UNITED STATES
NUCLEAR REGULATORY COMMISSION
WASHINGTON, D.C. 20555-0001

July 13, 2007

SUBJECT: MILLSTONE POWER STATION, UNIT NO. 2 - REQUEST FOR PROPRIETARY REVIEW OF DRAFT CORRECTIVE ACTIONS AUDIT REPORT FOR GENERIC SAFETY ISSUE - 191 RELATED TO GENERIC LETTER 2004-02

Figure 3.6.1.3.2-1 Walnut Shell Flour Particle Size Distribution

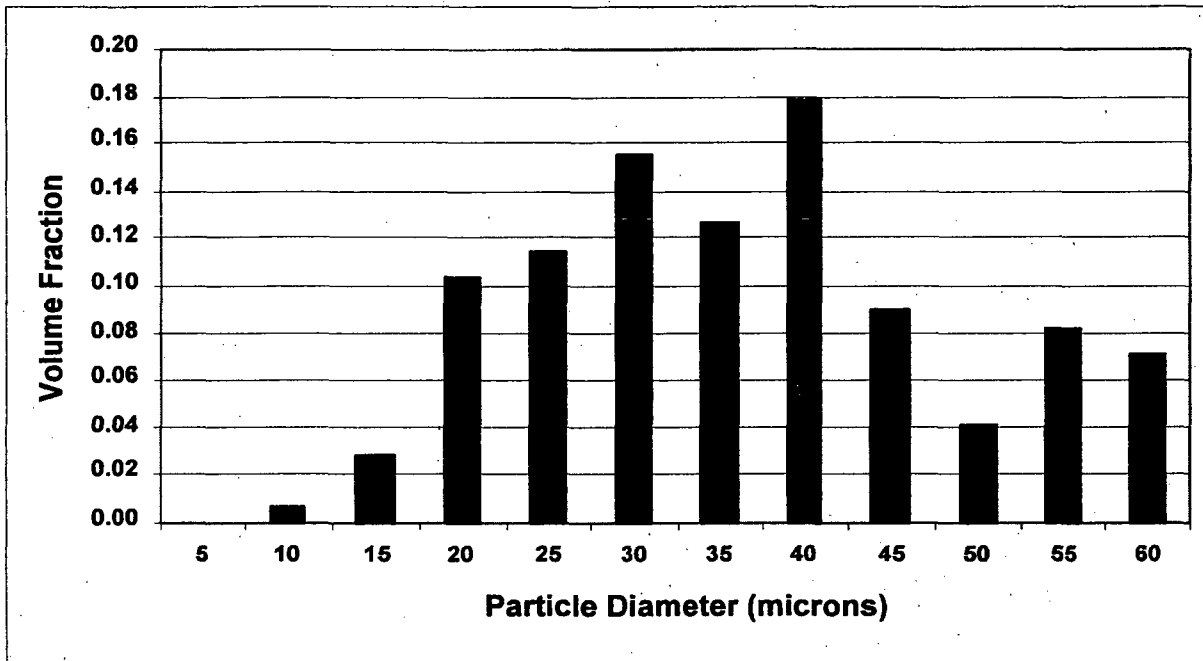
With regard to the head loss characteristics of the walnut flour, the only information provided directly to the staff was a particle size distribution obtained from the manufacturer. This size distribution, which is converted to volume fractions, is shown in Figure 3.6.1.3.2-1 below [125]. A detailed comparison of the walnut flour with coatings particulate was not available for review. The AECL analysis [page 5-3 of 124] of the walnut particle size distribution determined that the average size was about 23 µm, and (from a specific surface area consideration based on spherical particle shape assumption) the effective particle size was about 32 µm. This means that the walnut flour particles were a factor of about 3.2 larger than the GR recommendation, which translates to a factor of 10 decrease for head loss impact. Note that at the very low approach velocities associated with the Millstone replacement strainer, the head loss is approximately linear with the square of the specific surface area [123]. The specific surface area for the walnut flour size distribution, assuming spherical particles, is about 57,000 ft²/ft³, as compared to 183,000 ft²/ft³ for the SE-assumed particulate. Therefore, if only the walnut flour hydraulic characteristics are considered, a conclusion could be drawn that walnut flour may not be a good surrogate material to meet GR and SE coatings requirements.

The staff conducted its own evaluation of the use of walnut shell flour for head loss testing. The staff found that the flour consists of mostly cellulose with about 28% lignin and a few other ingredients in lesser amounts. Normally, the cellulose products (e.g., wood surfaces) have a somewhat honeycomb structure. It is reasonable to assume that in mechanically breaking such a structure into particulate the particles may not be spherically shaped. The particles could for example be more plate-like than spherical. If the particles are not spherical, then the effective specific surface area of the walnut flour cannot be estimated using a simple geometrical formula.

Figure 3.6.1.3.2-2 Walnut Shell Flour Specific Surface Areas Experimentally Deduced by NRC Staff from Thin-Bed Tests

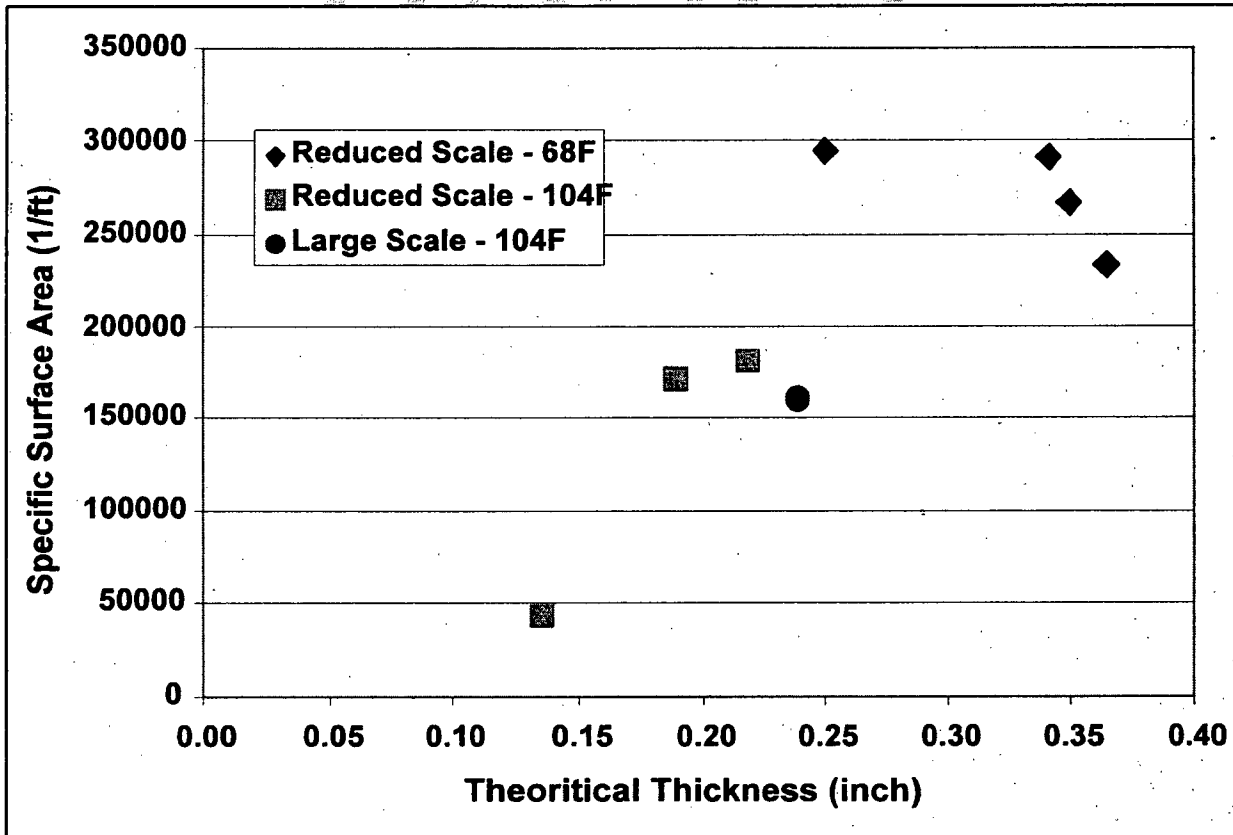
The following observations were made from Figure 3.6.1.3.2-2:

- The staff deduced specific-surface area values for walnut shell flour, which are shown in Figure 3.6.1.3.2-2. These values are close to that for hypothetical 10 µm spherical particles (183,000 ft²/ft³) found in the GR [1]. As demonstrated in [11], head loss characteristics are strongly correlated to specific surface area. Therefore, the experimental evidence strongly indicates that the head loss characteristics of the walnut shell flour are close to the GR-recommended 10 µm spherical particle, and may even be conservative with respect to the GR guidance.

Figure 3.6.1.4-1 Millstone Unit 2 Strainer Array.

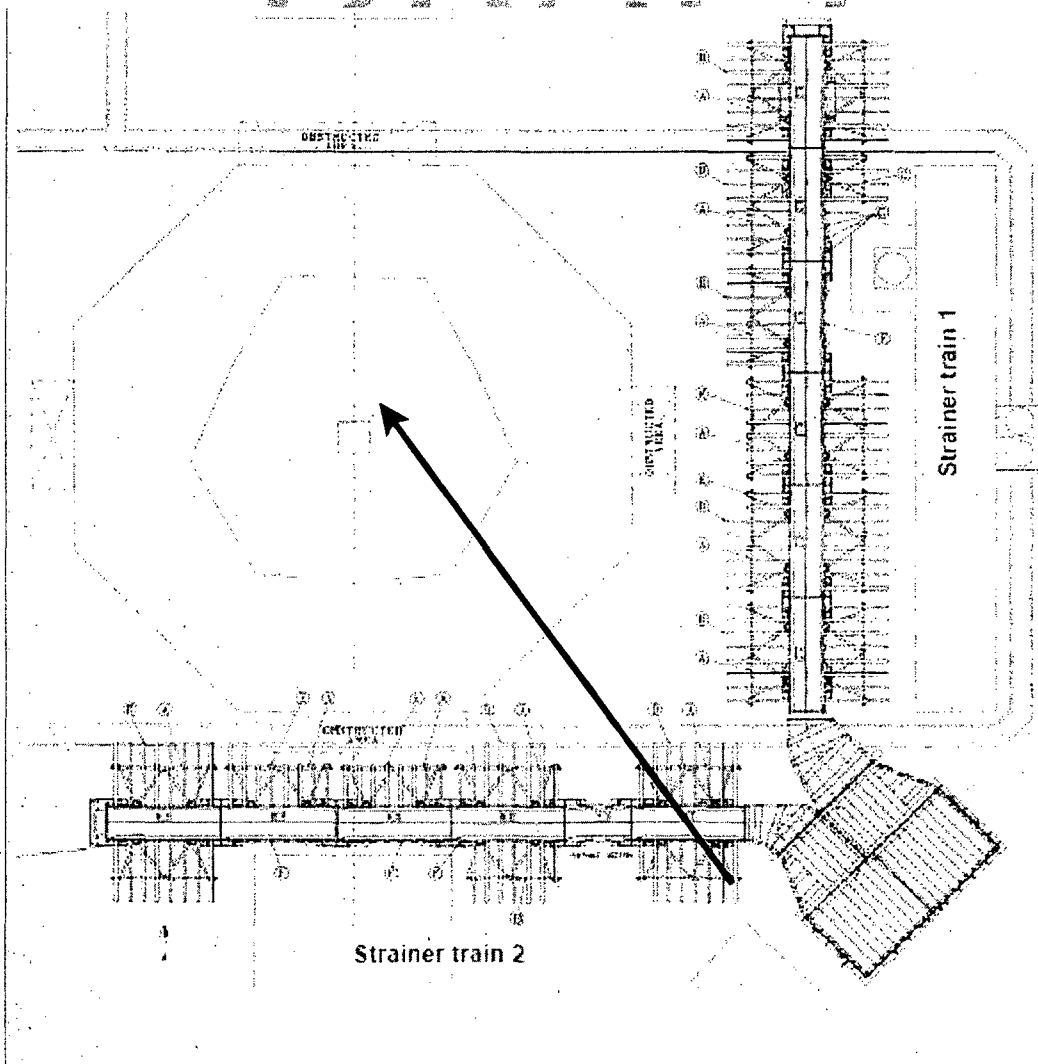
In order to maximize the strainer surface area in the available space of Millstone Unit 2 containment, two trains of strainer modules were connected to the pump intakes, as shown in Figure 3.6.1.4-1. Initially, all these strainer modules were designed to be connected to the central common header. However, after an undocumented large-scale strainer head loss test demonstrated that the strainer arrays without uniform flow control experienced sequential debris deposition and the final total head loss was much higher than that with an uniform debris distribution, AECL decided to add an internal orifice to each strainer module to force a uniform flow through the entire array. Figure 3.6.1.4-2 shows the internal orifice and the connection with the large central flow path. The orifices for all these modules were sized to provide appropriate resistance to correctly balance the flow. In this way, all modules from both trains are expected to experience reasonable uniform debris deposition and lower overall head loss.

In summary, the licensee performed plant-specific prototypical strainer head loss testing to measure the head loss across the AECL strainer arrays with Millstone Unit 2 plant specific debris loading. The testing matrix, the testing procedures and the system input evaluation were reviewed during the audit. Because the predicted total debris bed head loss of 0.35 psi [127] under the design temperatures conditions is significantly less than the 2.3 ft NPSH margin predicted, the staff considers the licensee's head loss evaluation adequate under the current LOCA single failure assumption (excluding any potential head loss change due to chemical

effects). With the design input provided by the licensee, AECL performed thorough hydraulic analyses, developed a proper strainer design, and conducted well-defined head loss tests providing a solid justification for the current design. However, two NPSH-related open items documented in Sections 3.6.2.2 and 3.6.2.3.1 of this report should be addressed by the licensee.
